CHATSWOOD TO SYDENHAM
**MARTIN PLACE STATION
MODIFICATION REPORT**

6 Modification description – operation

6.2 Proposed modification

Figure 6-2 Martin Place Station – proposed modification layout

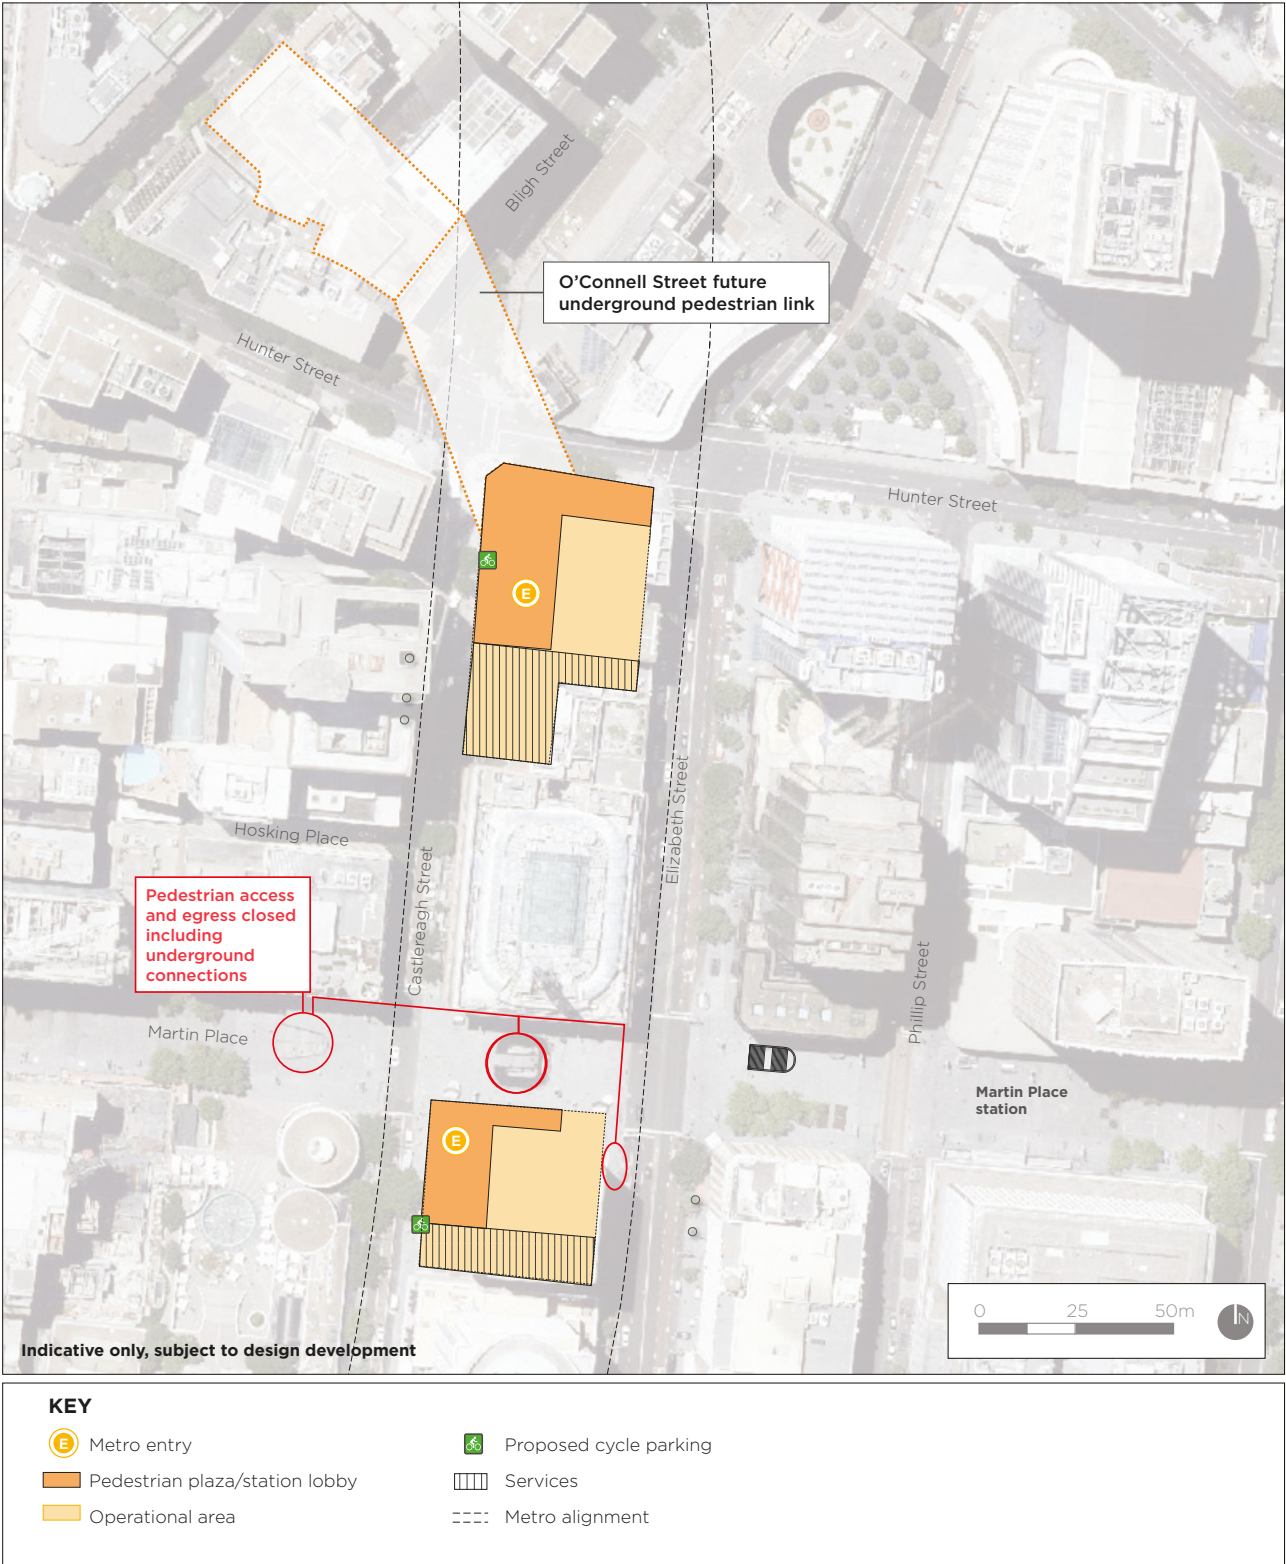
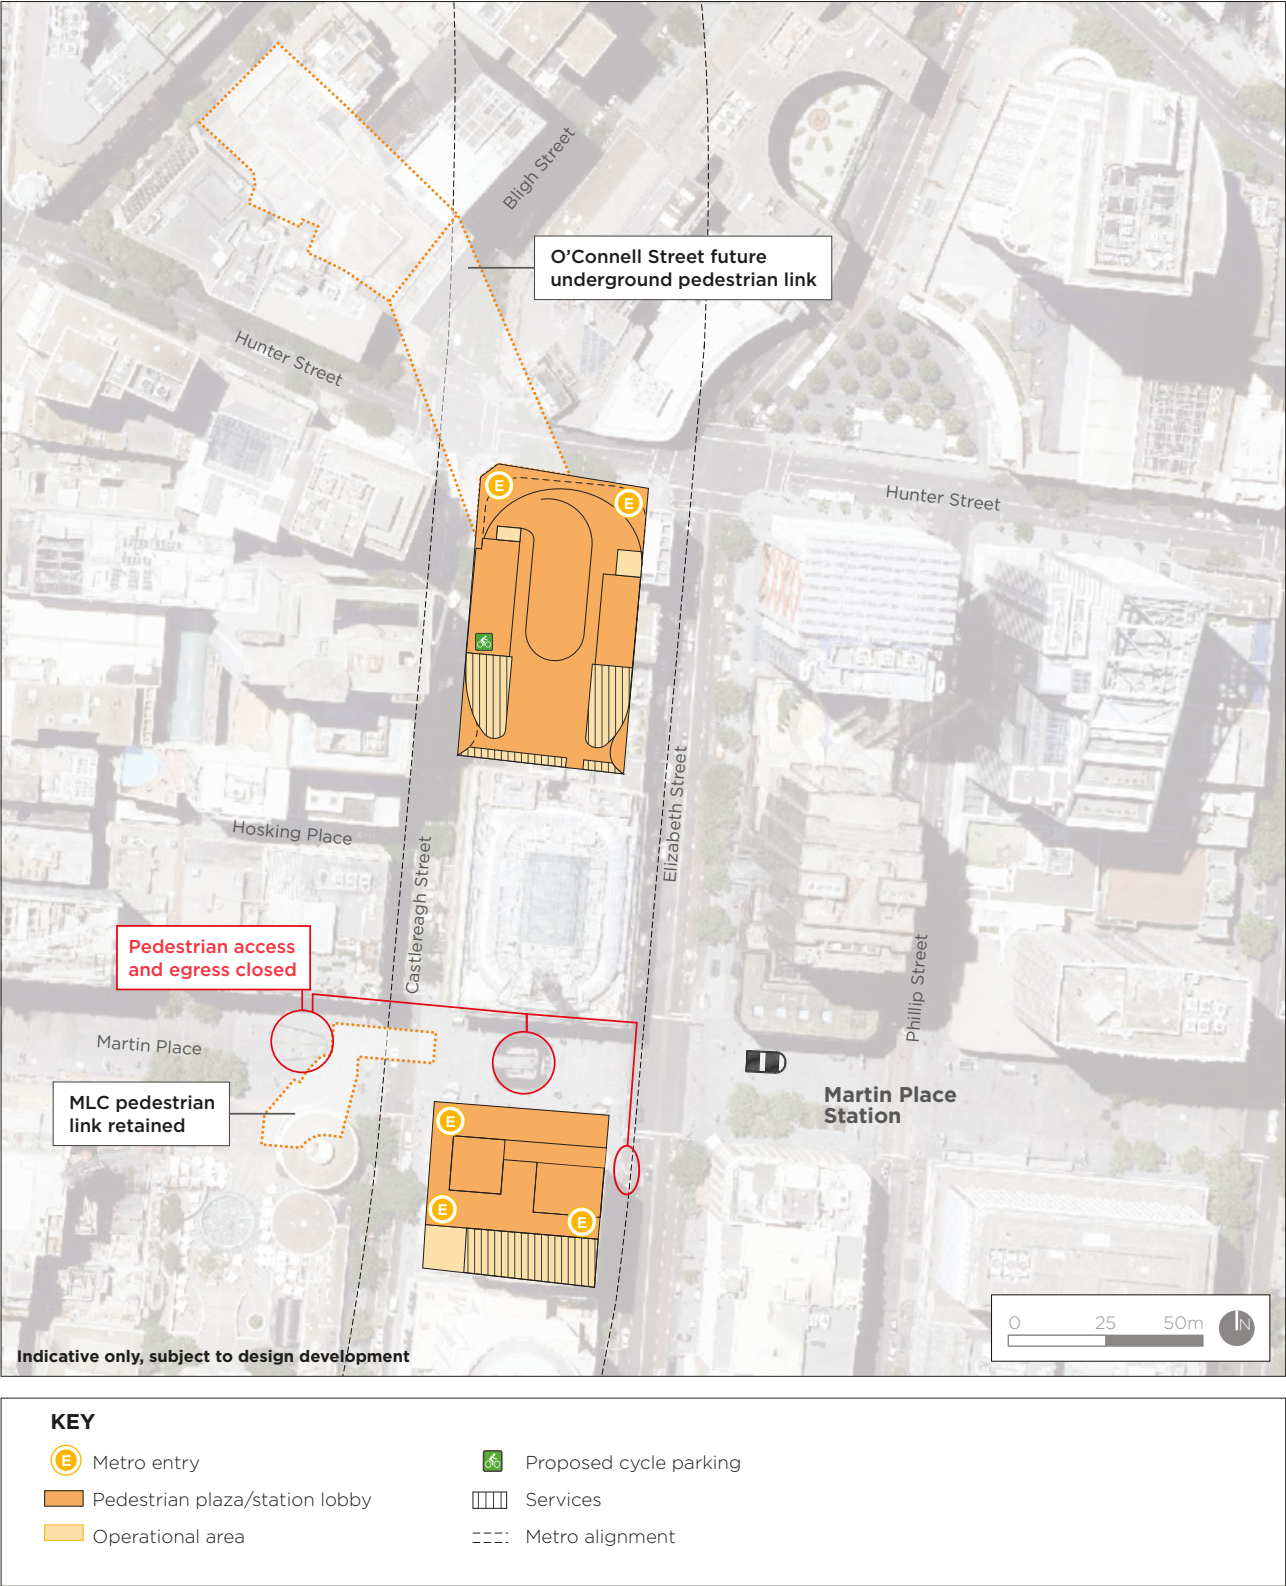
Figure 6-1 shows the approved project layout of the Martin Place Station entries. Figure 6-2 demonstrates the modified station footprint and indicative layout for the northern and southern entrances of Sydney Metro Martin Place Station.

Figure 6-4 Proposed modification cross-sections

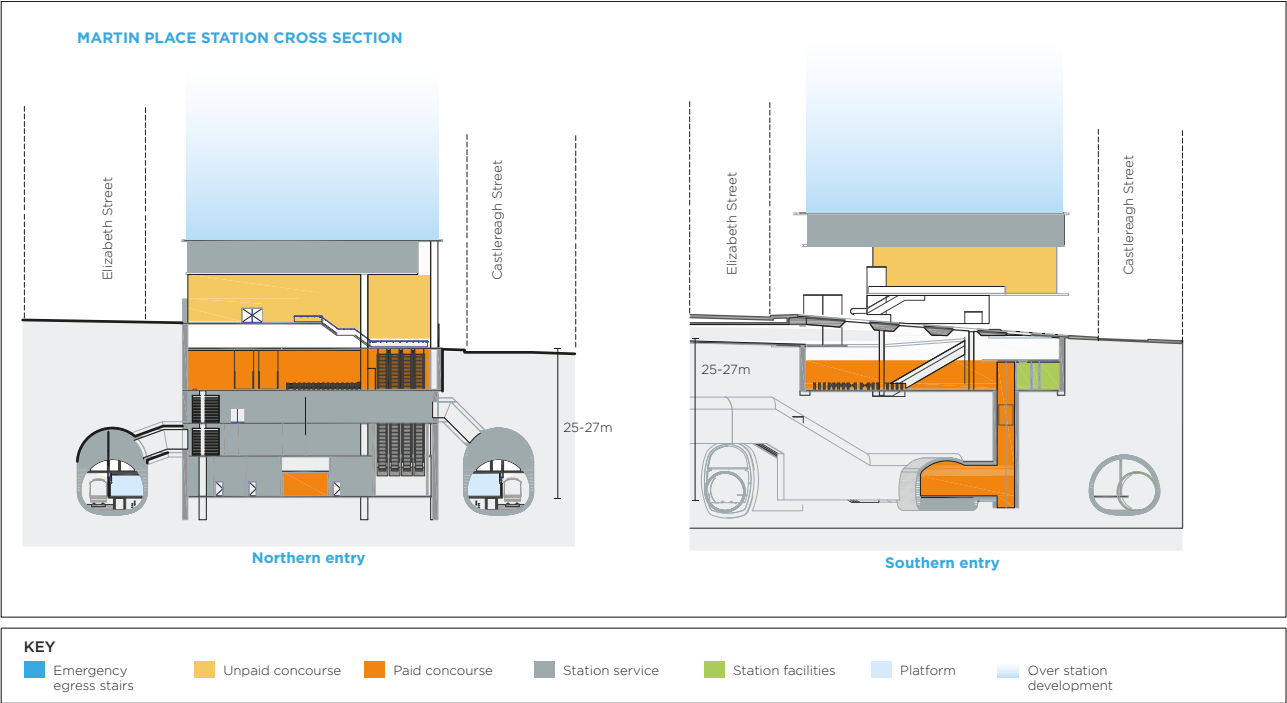
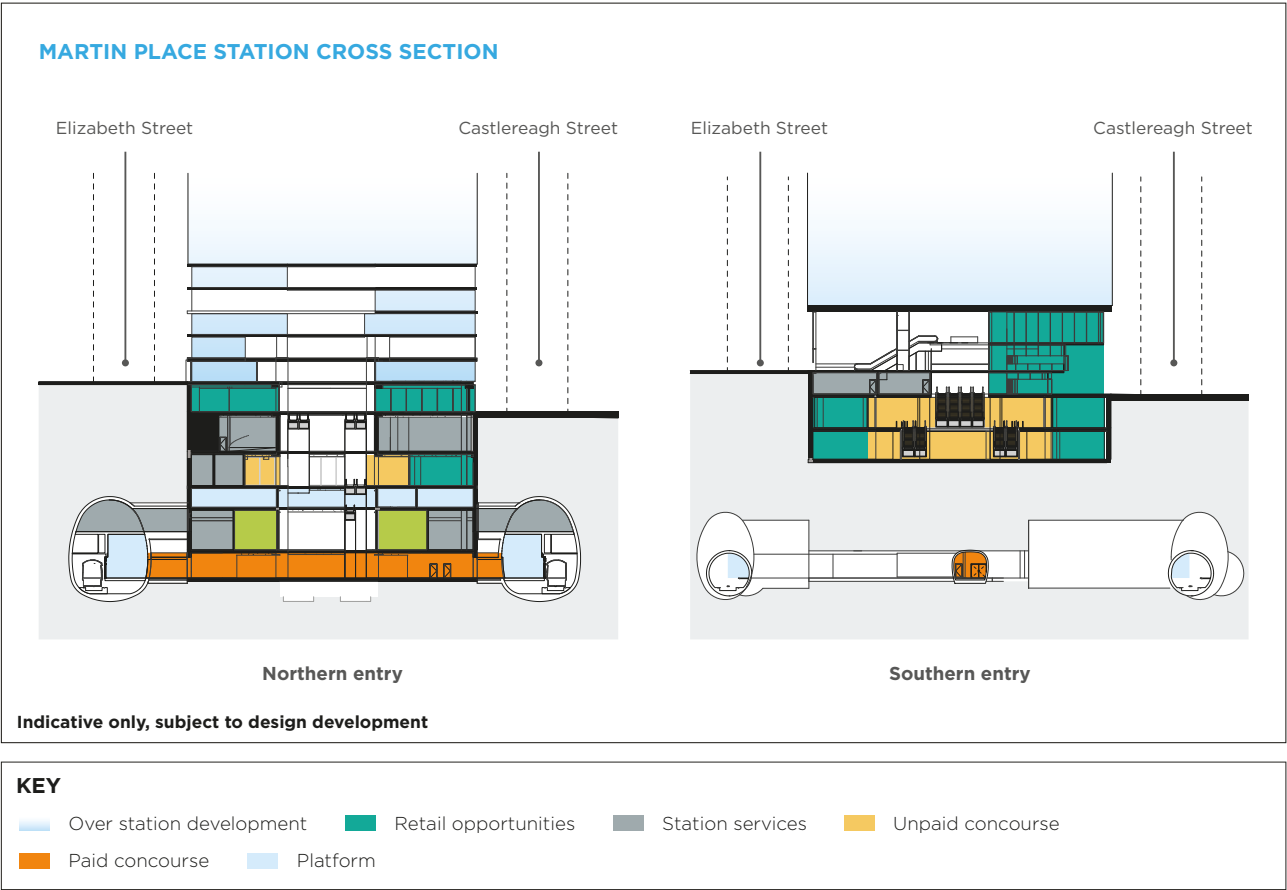
Figure 6-3 shows the cross-sections of the northern and southern station entries for the approved project, including the interface with the over station development. Figure 6-4 shows cross-sections of the proposed modified Martin Place Station for the northern and southern entrances.

Figure 6-6 Proposed modification long-section showing unpaid concourse link

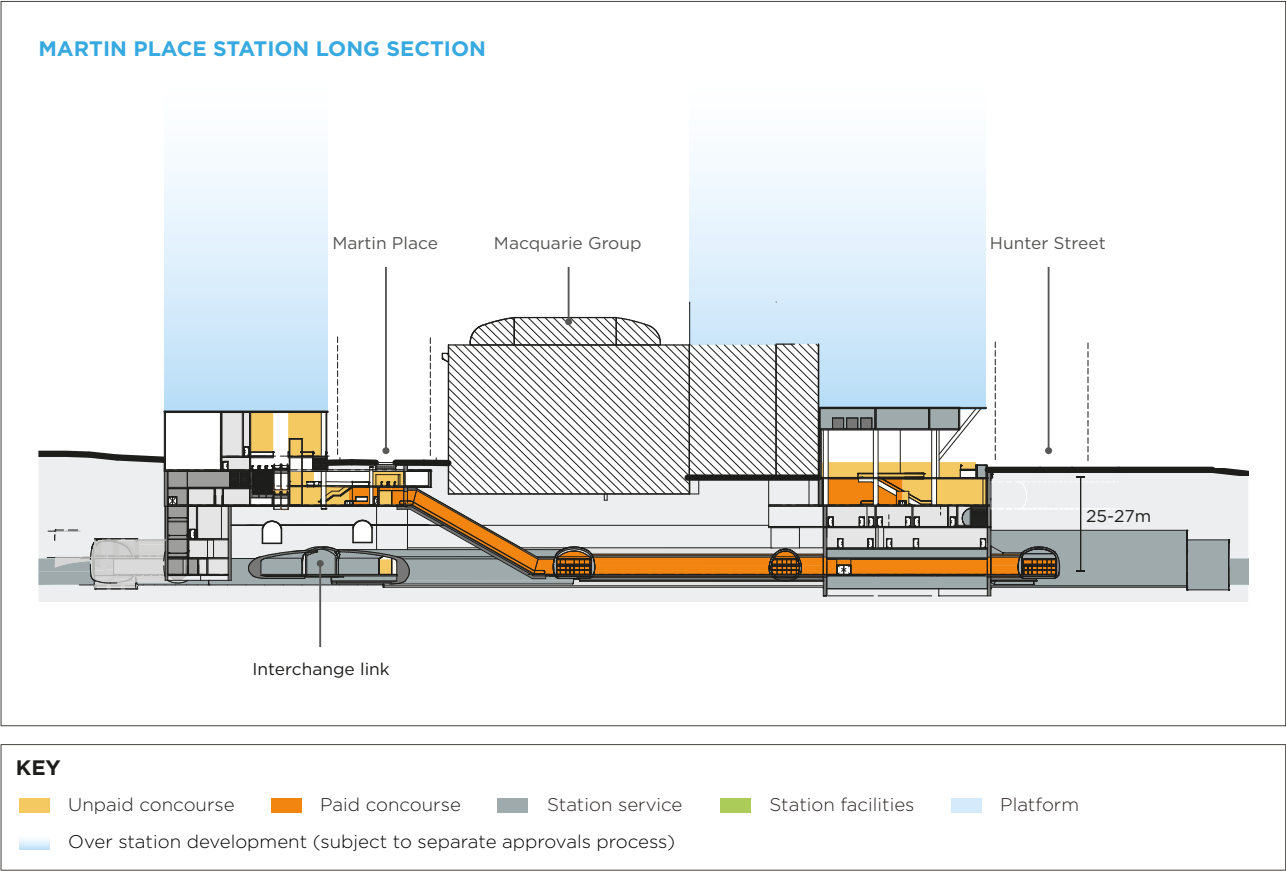
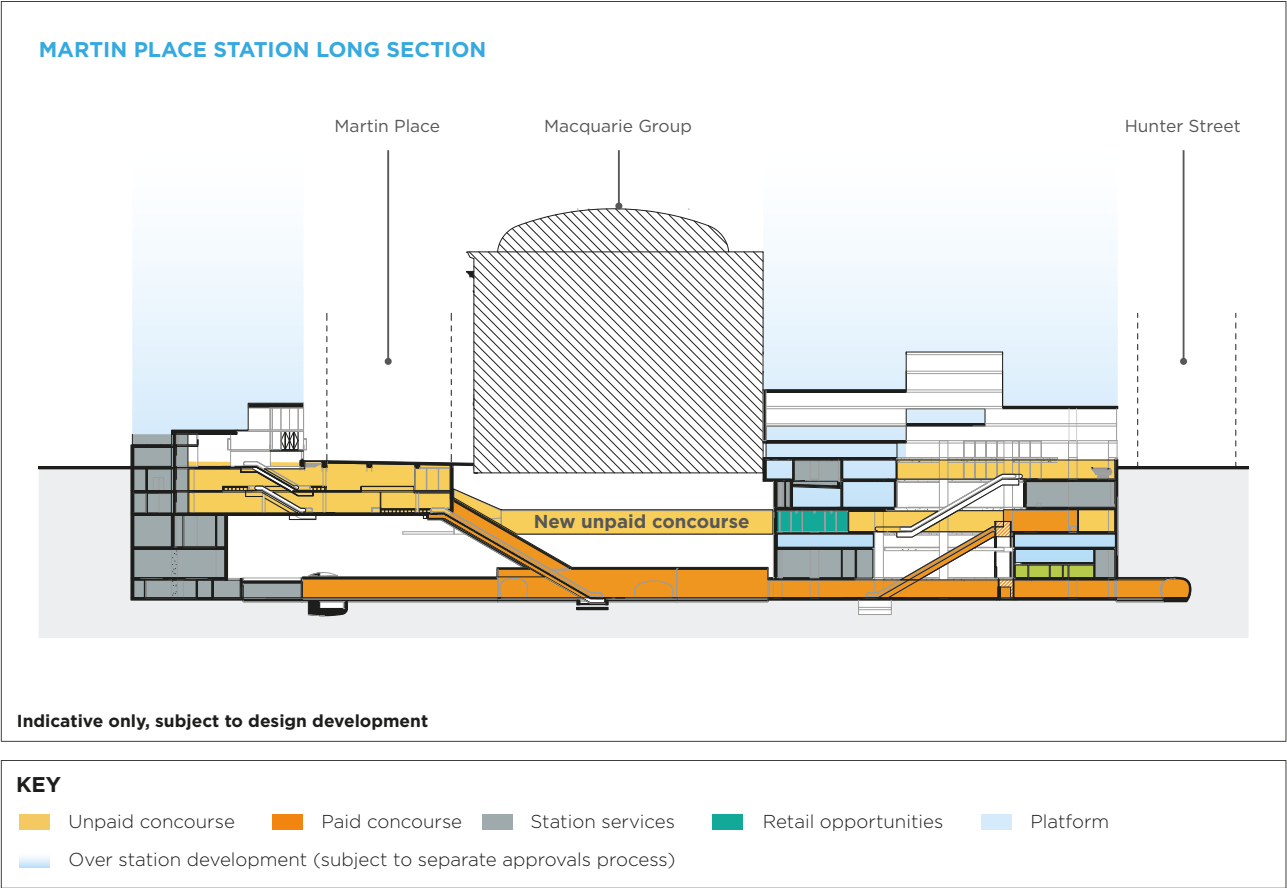
A new unpaid concourse link is proposed beneath 50 Martin Place providing an underground connection between both station entries and the existing Sydney Trains Martin Place Station. Figure 6-5 shows a long section of the approved project. Figure 6-6 shows a long section of the proposed modification including the new concourse link between the northern and southern entries. An artist's impression of the new concourse link is provided as Plate 6-1.
